MBC COOLING WATER SYSTEM CHILLER UPGRADE

The following changes to the Contract Documents are hereby made effective as though originally issued with the bid package. Bidders are reminded that all previous requirements to this solicitation remain in full force and effect.

ADDENDUM C

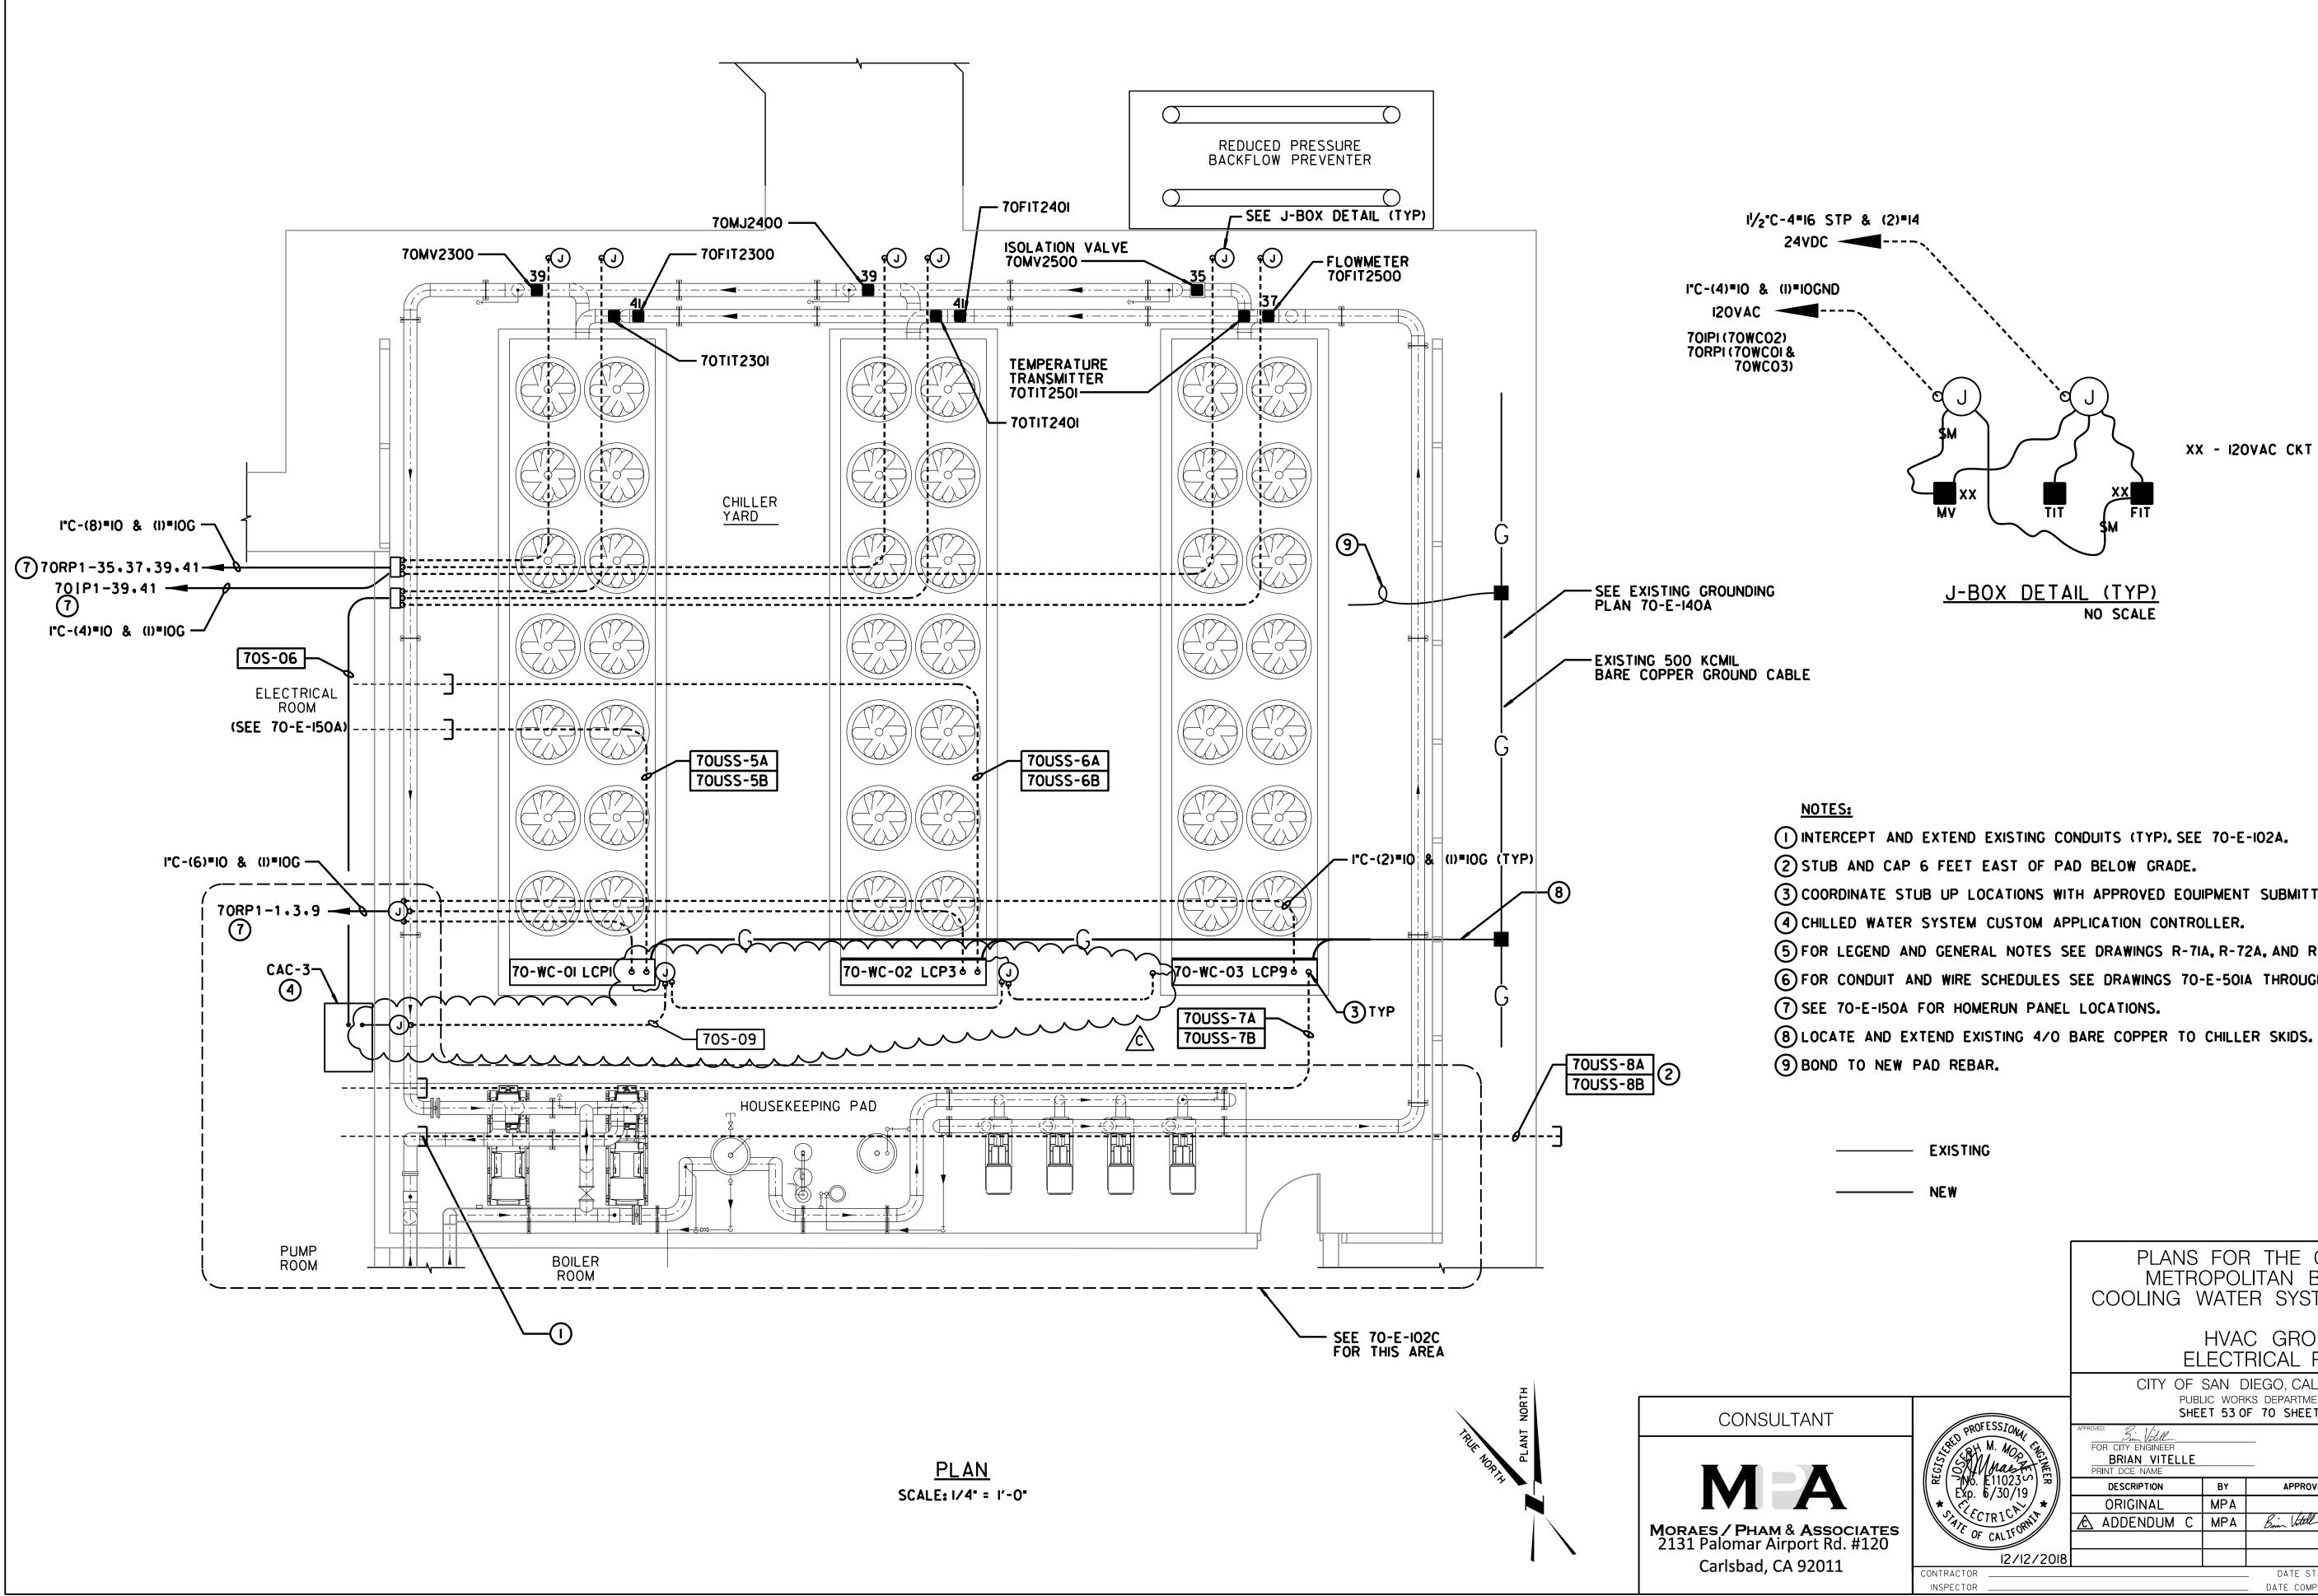
NEW				_							
					70	–E–102B					
	PLANS FOR THE CONSTRUCTION OF METROPOLITAN BIOSOLIDS CENTER COOLING WATER SYSTEM CHILLER UPGRADE										
			C GROUNE RICAL PLAN								
	PUBL	IC WOR	DIEGO, CALIFORN ks department f 70 Sheets	NIA		WBS <u>B-16165</u>					
PROFESSIONAL CHE ON M. MODIFIES STATEMENT THOSE FILLING THOSE	FOR CITY ENGINEER BRIAN VITELLE PRINT DCE NAME		DATE	/13/2018 73039		UBMITTED BY: IDALMIRO DA ROSA PROJECT MANAGER CHECKED BY:					
$\begin{bmatrix} 2 \\ -1 \\ -1 \\ -1 \\ -1 \\ -1 \\ -1 \\ -1 \\ $	DESCRIPTION	BY	APPROVED	DATE	FILMED	DRCE LARRIVA					
* S. C.C.T.R.I.C.P. * * J.E. OF CALIFORNIT	ORIGINAL	MPA MPA	Brian Wittell	3/4/19		246-1719 CCS27 COORDINATE					
12/12/2018						1886444-6280407 CCS83 COORDINATE					
CONTRACTOR			_ DATE STARTED _ DATE COMPLETED			40054-53-D					
ADD 705-09	ADDEN	١D		\mathcal{C}

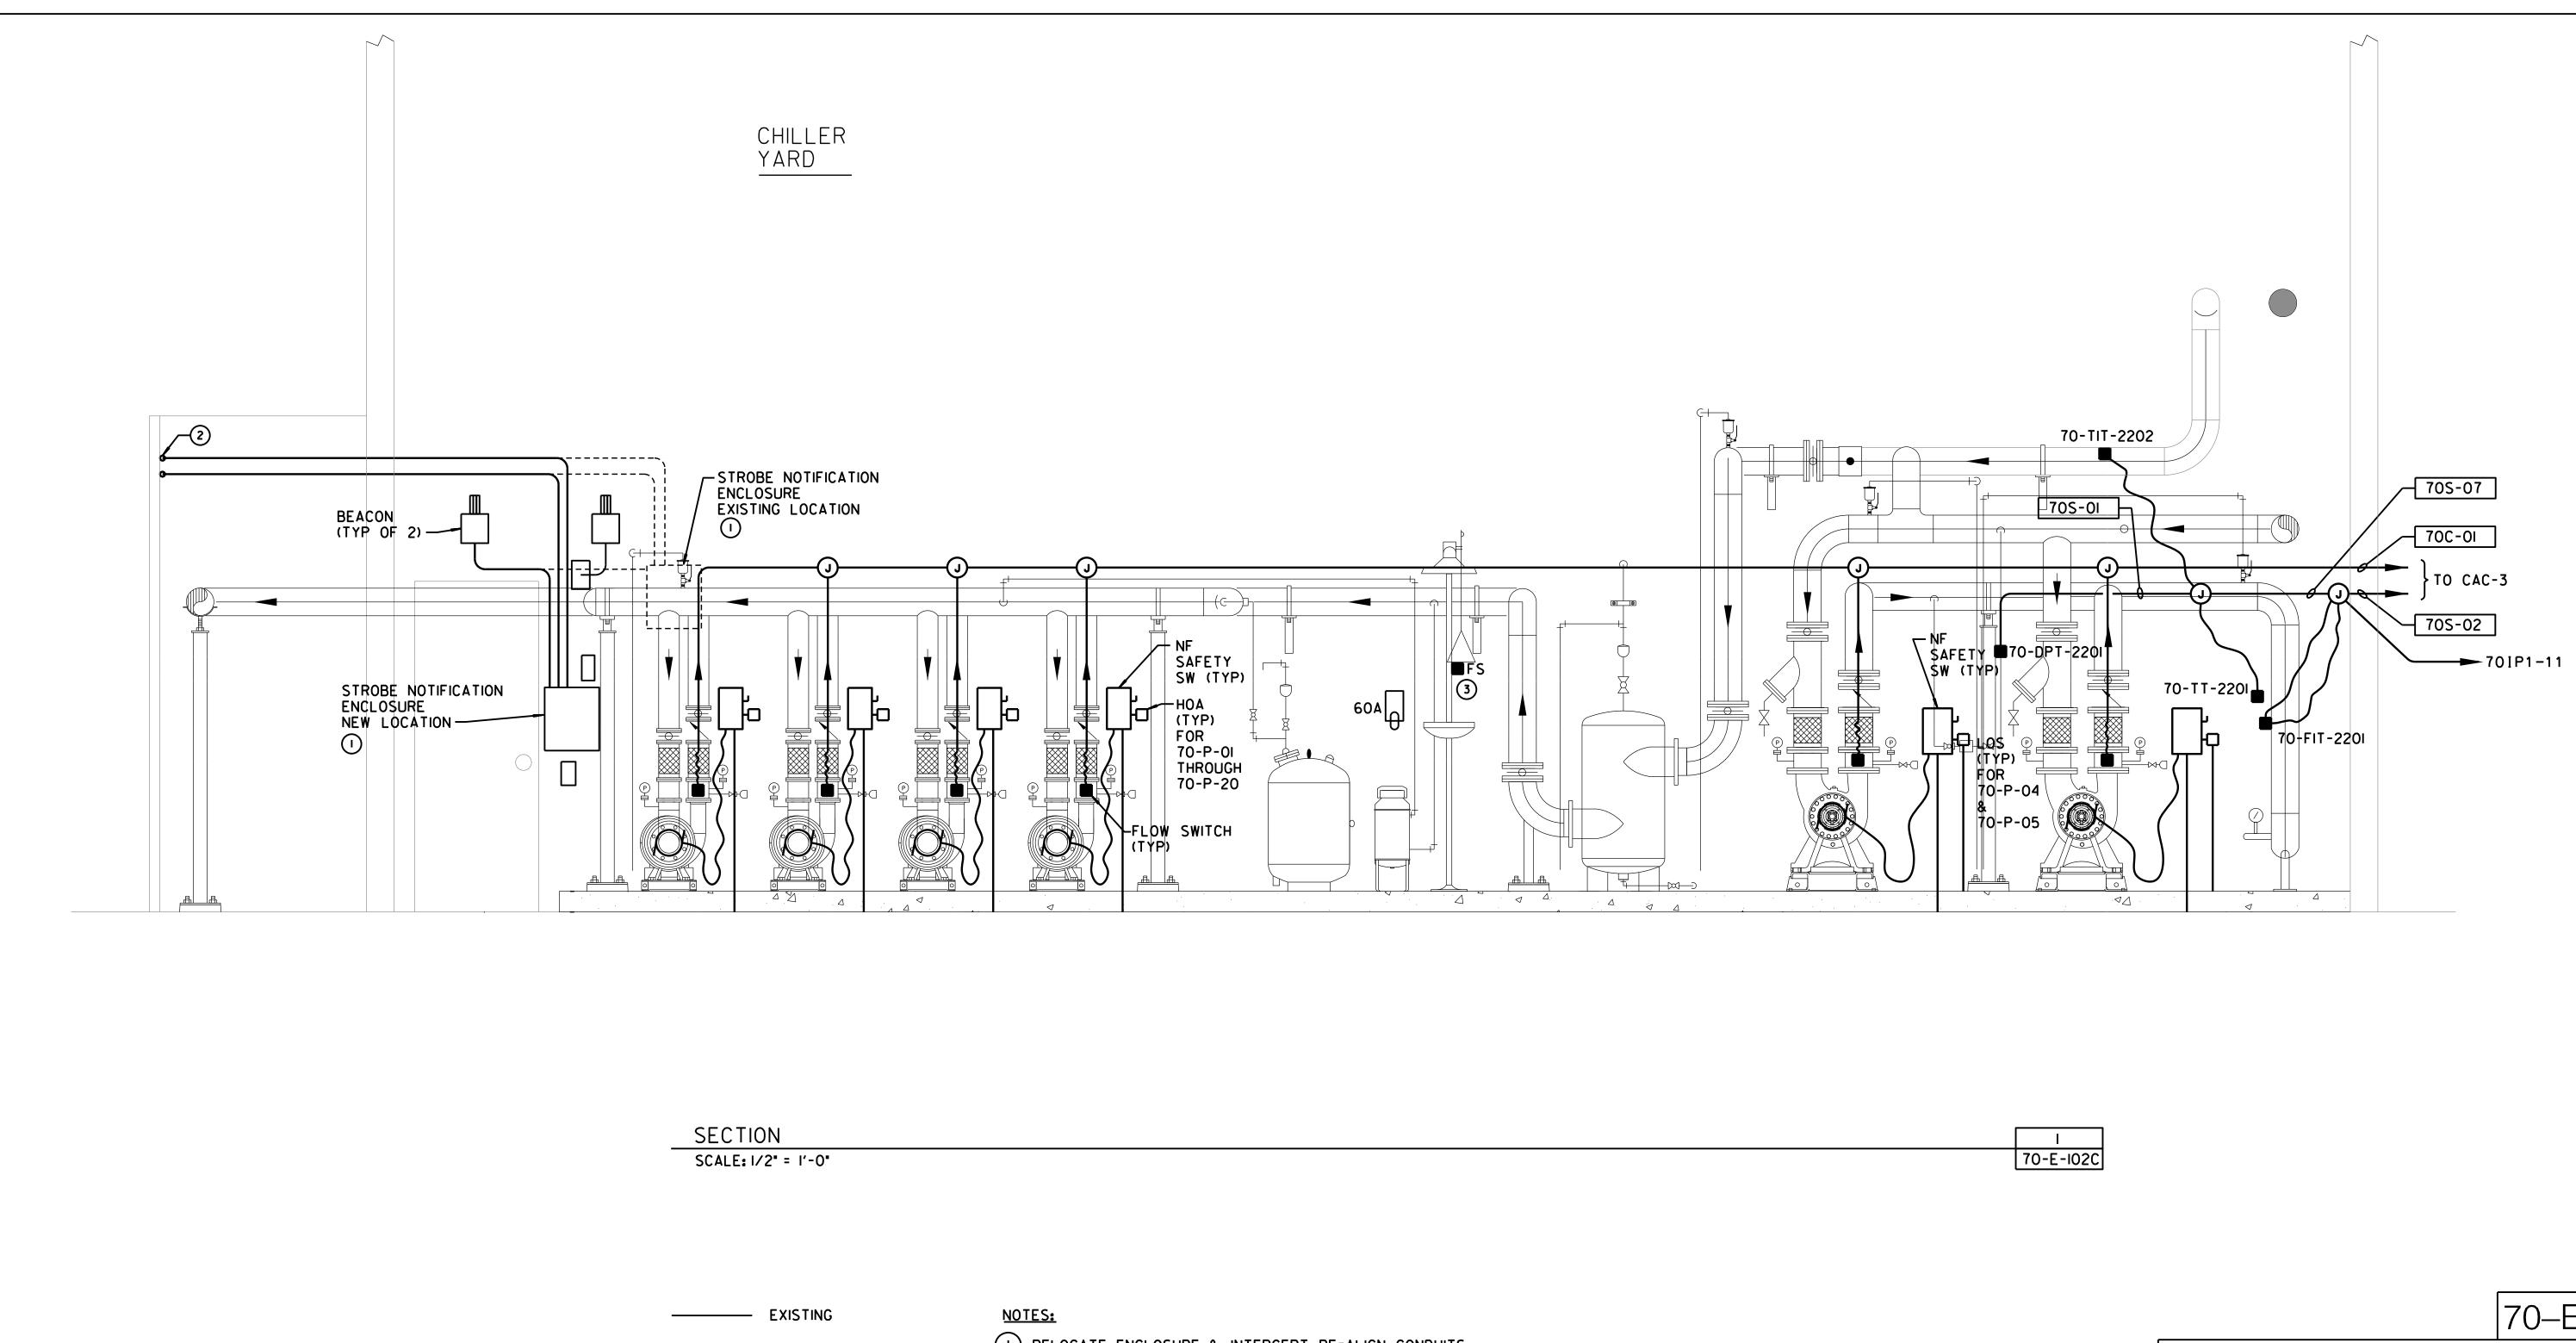
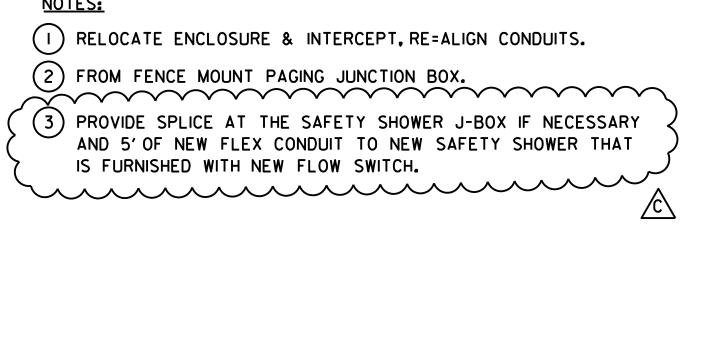
\bigcirc
					70	-E-102D	\bigcirc
	METRO	OPOL	R THE CONS LITAN BIOSC ER SYSTEM	DLID	S C		MBC
		ELE	CTRICAL SE	CTIC	DN		
	PUBL	IC WOR	DIEGO, CALIFORNI ks department i f 70 Sheets	A		WBS <u>B-16165</u>	
HID PROFESSIONAL HID PROFESSIONAL HID PH M. MOD HID PH M. MOD HID PH HALL	FOR CITY ENGINEER BRIAN VITELLE PRINT DCE NAME	JimJill12/13/2018FOR CITY ENGINEERDATEBRIAN VITELLEC73039				IDALMIRO DA ROSA PROJECT MANAGER CHECKED BY: JORGE LARRIVA	
\mathbb{E} \mathbb	DESCRIPTION	ΒY	APPROVED	DATE	FILMED	PROJECT ENGINEER	
* ST FECTRICA *	ORIGINAL	MPA MPA	Brian Vittell	3/4/19		246-1719 CCS27 COORDINATE	
12/12/2018						I <u>886444-6280407</u> CCS83 COORDINATE	
CONTRACTOR INSPECTOR			DATE STARTED DATE COMPLETED			40054–55–D	
REPLACE NOTE 3	ADDEN	ND	UM C)		Page 188 o	f 180
